PHAP25-00045

ITEM #2

Reconsideration of a Certificate of Appropriateness for the placement of a metal structure in driveway after-the-fact

The Historic Preservation Office recommends APPROVAL WITH MODIFICATIONS of the proposed scope of work based on the following recommendations:

PREVIOUS PROPOSAL

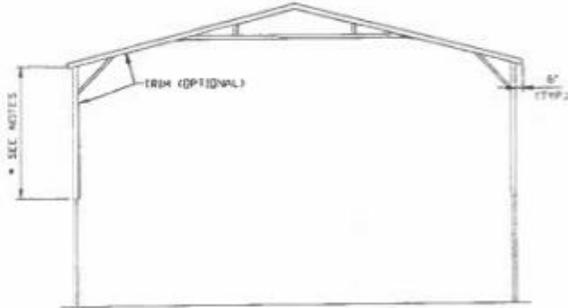
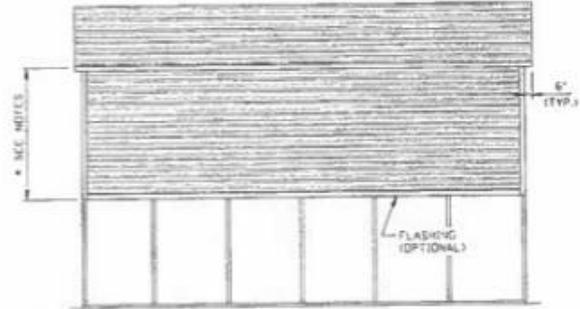
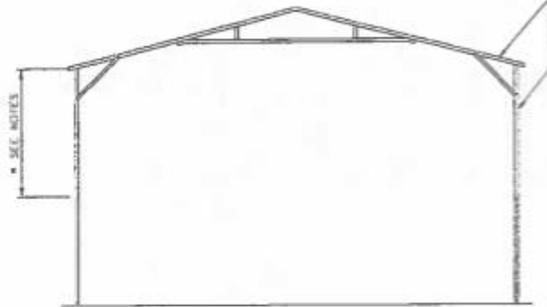
The modification is that the new structure be a wood pergola.
